The Northern Road Upgrade – Mersey Road, Bringelly to Glenmore Parkway, Glenmore Park

Submissions and Preferred Infrastructure Report Volume 1: Main Report

Roads and Maritime Services | December, 2017

Figure 4-1 | Overview of design refinements for the project

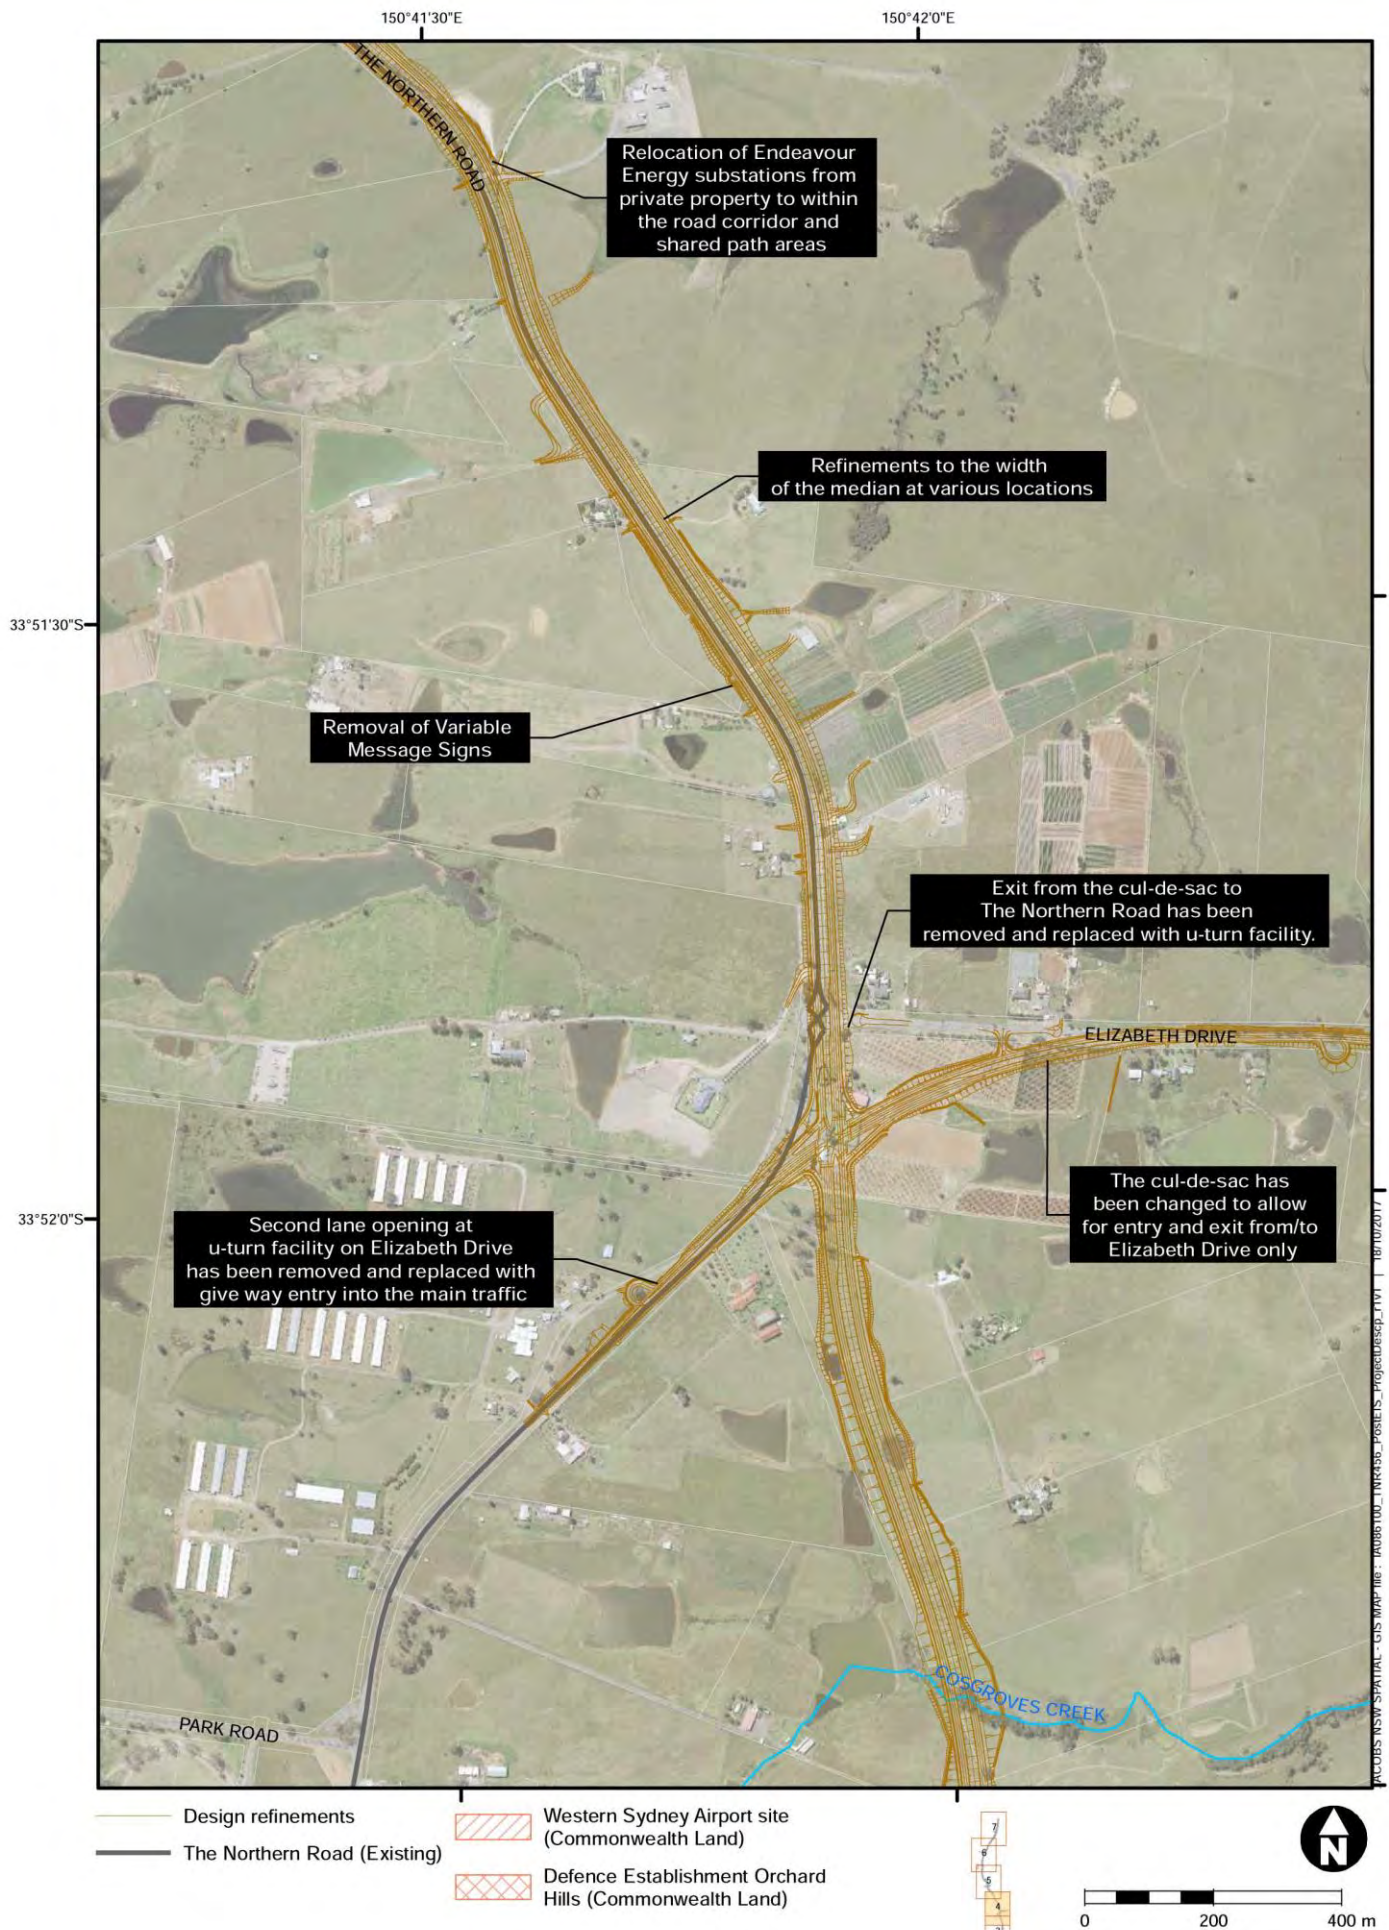
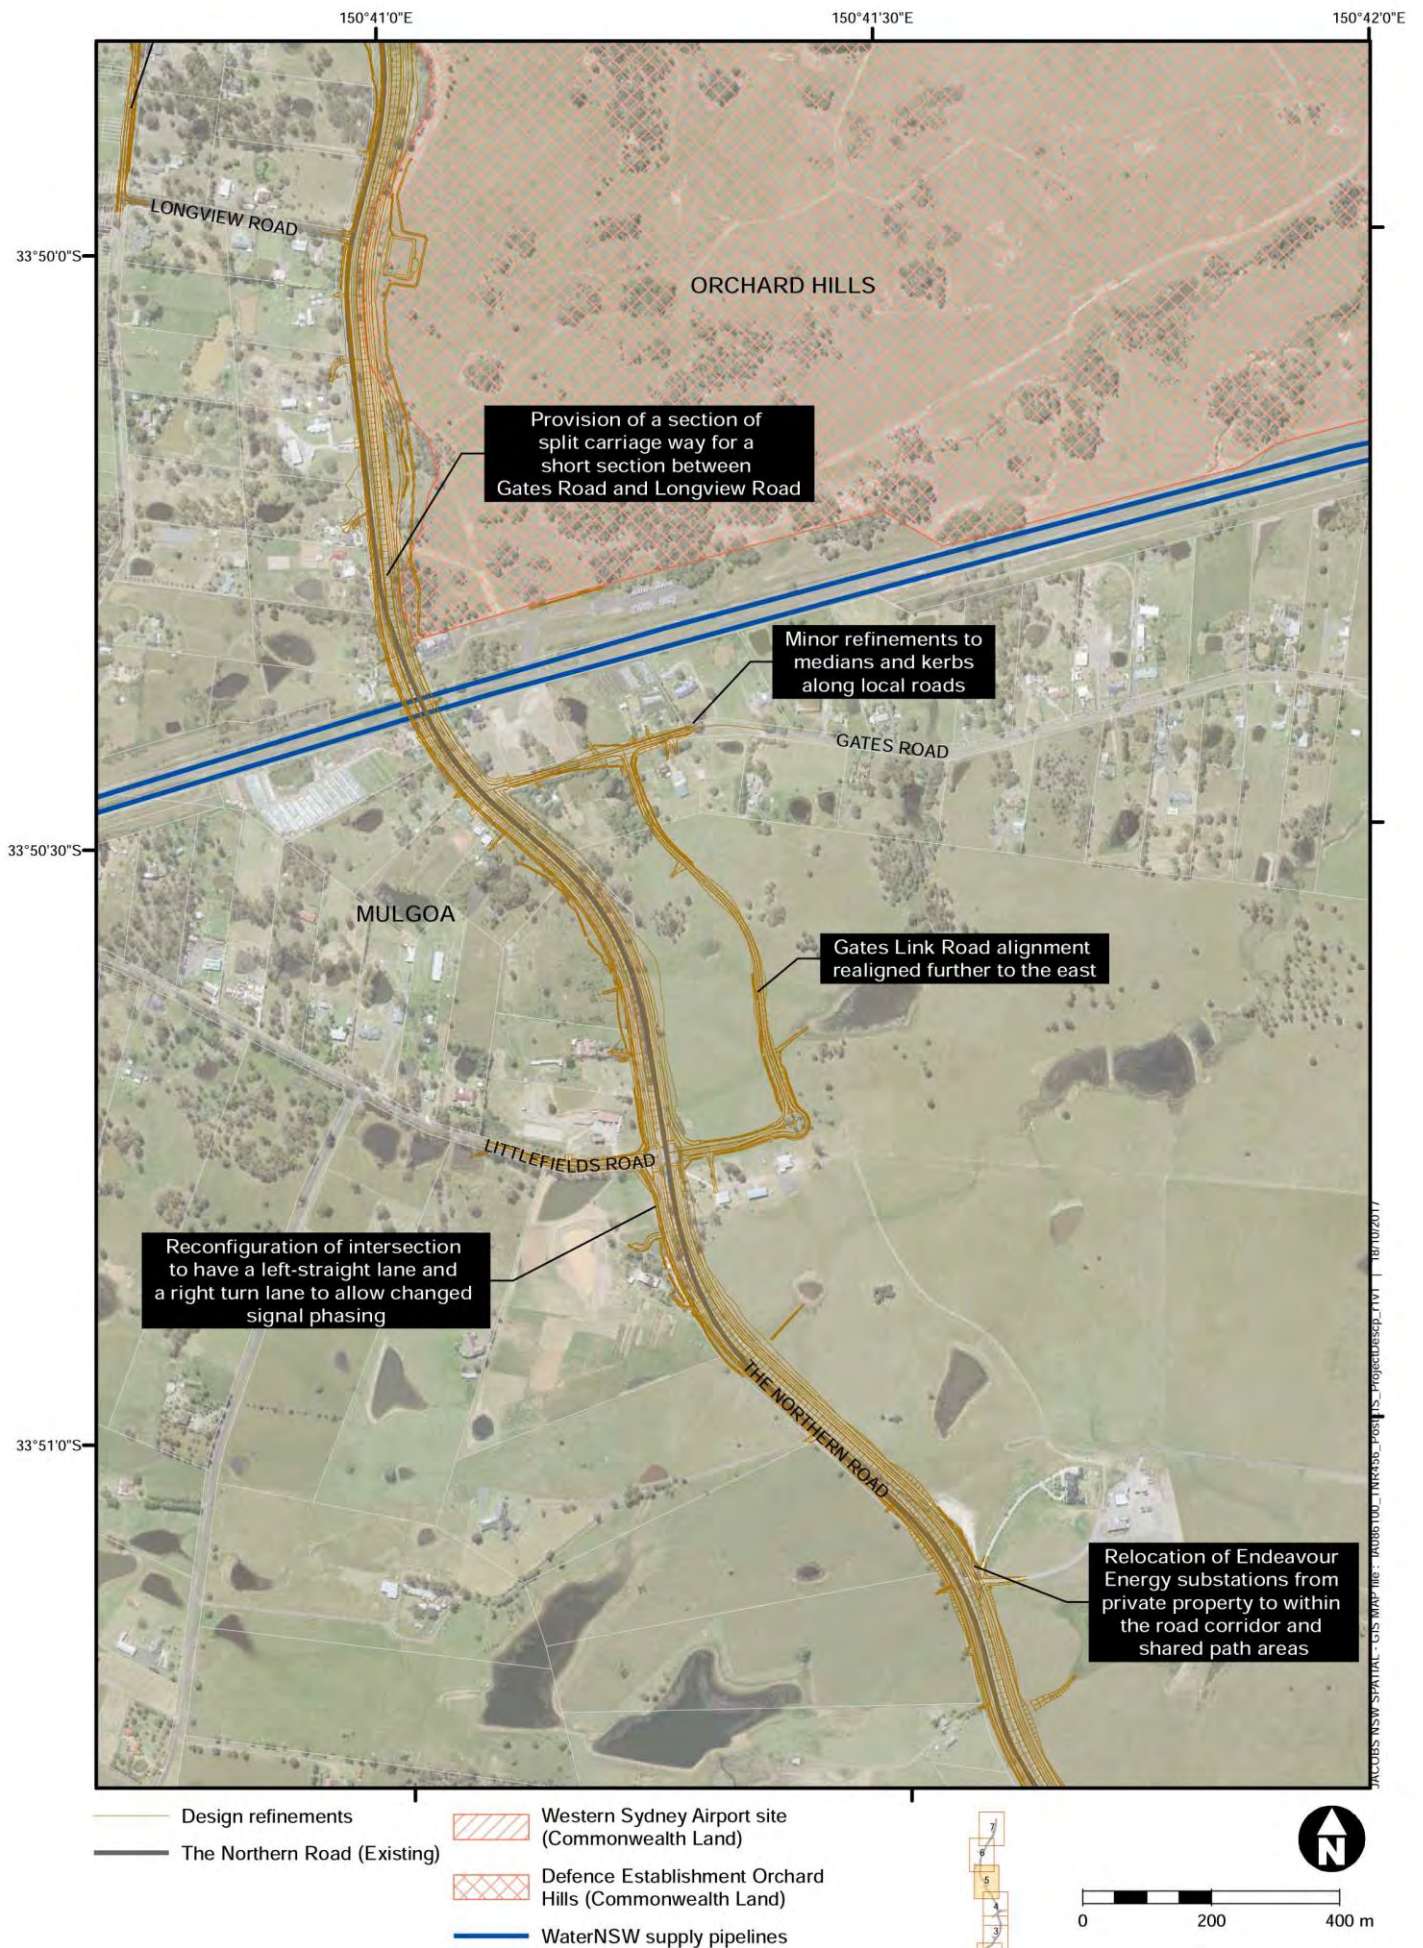
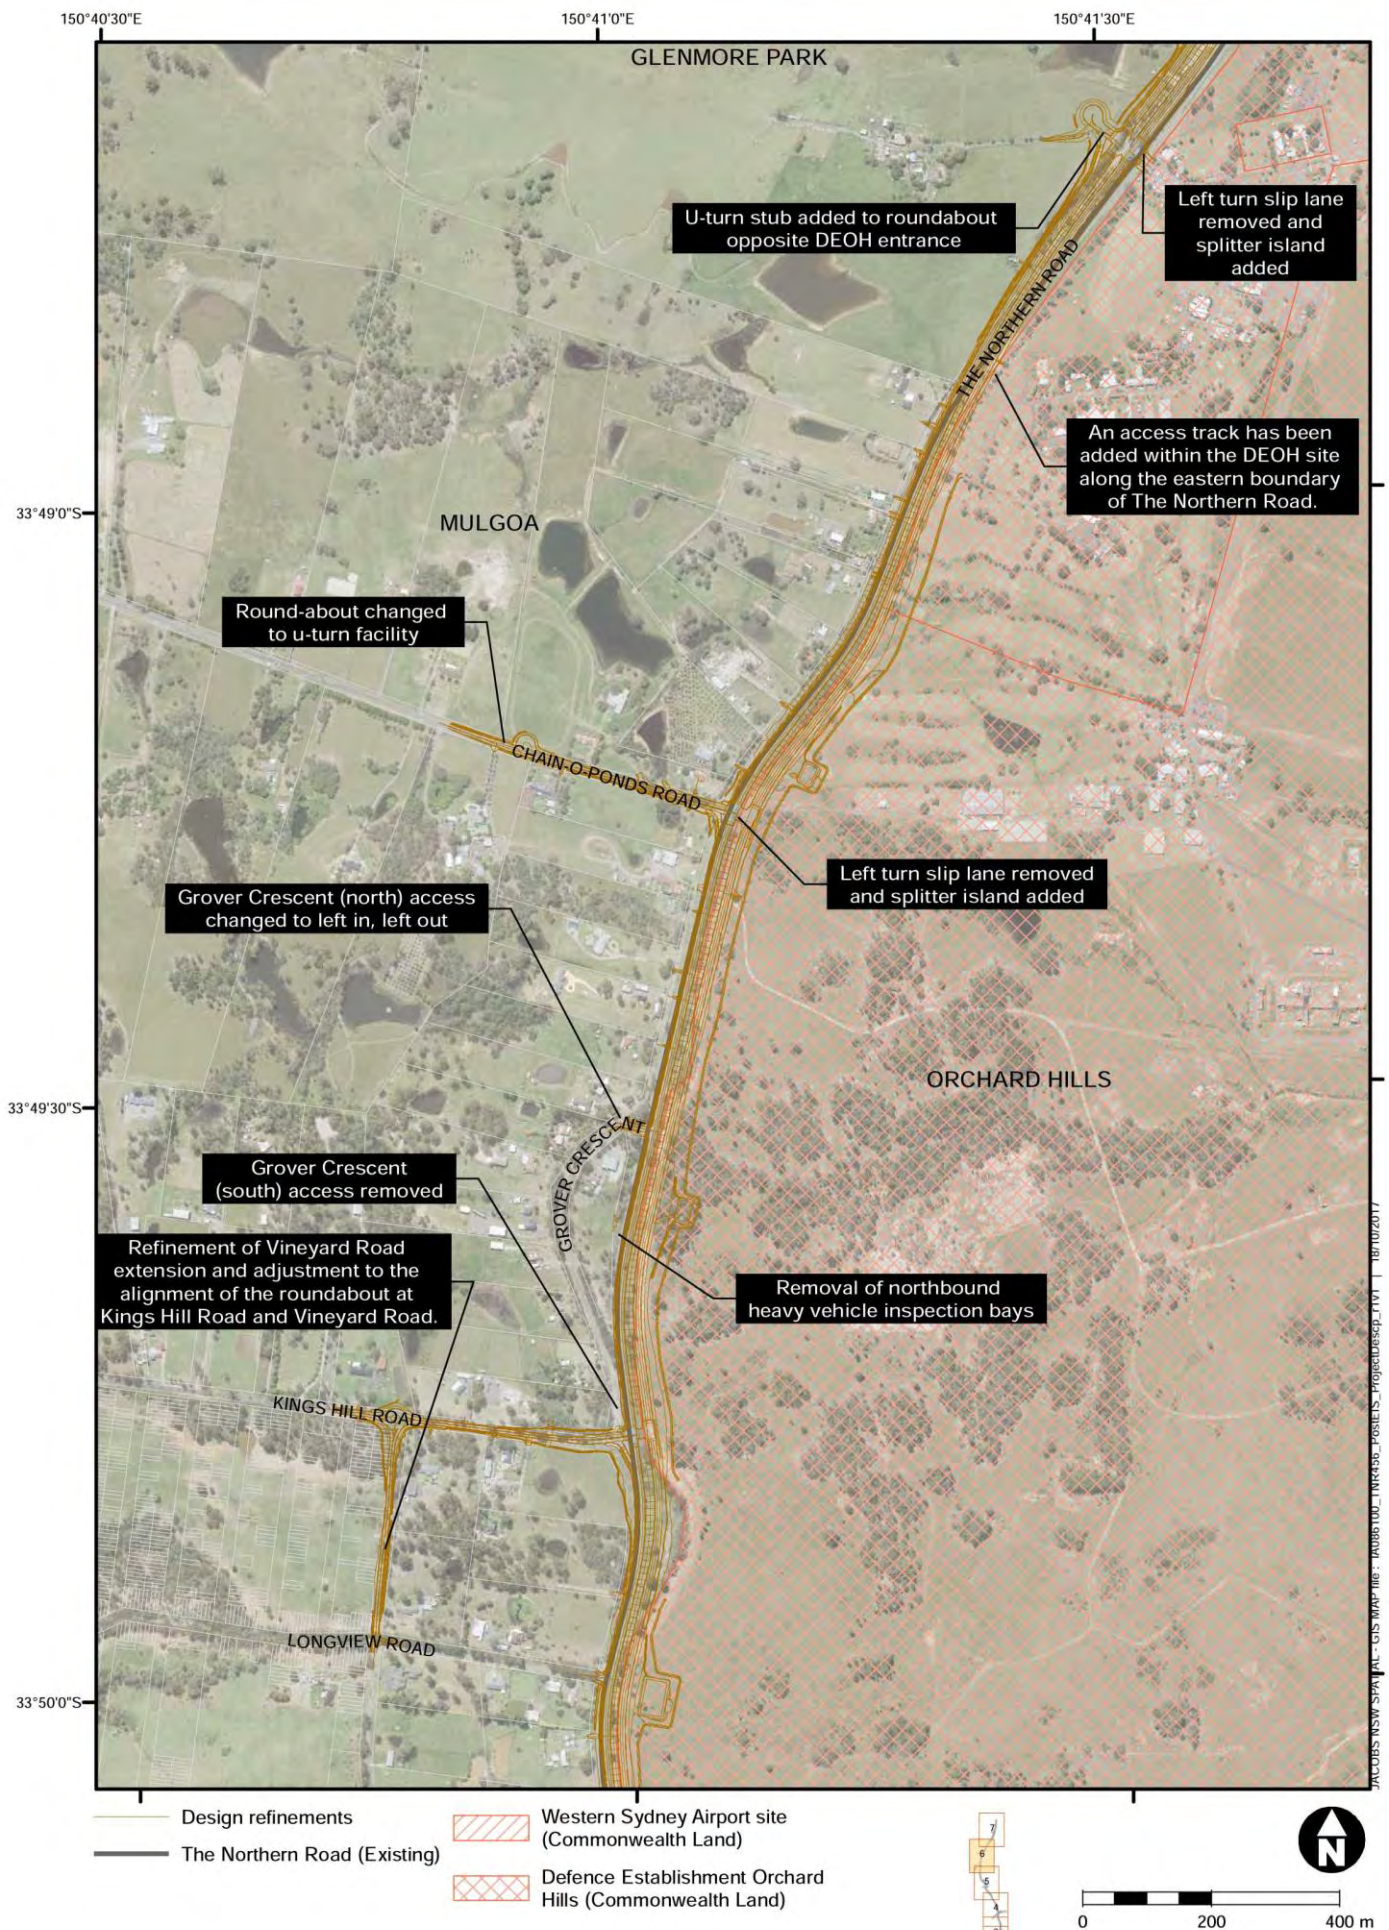
An overview of the design refinements for the project is provided in Table 4-1. This includes details of the justification for the change and any further environmental assessment undertaken since exhibition of the EIS in order to assess the change. Figure 4-2 provides an overview of the key design refinements.
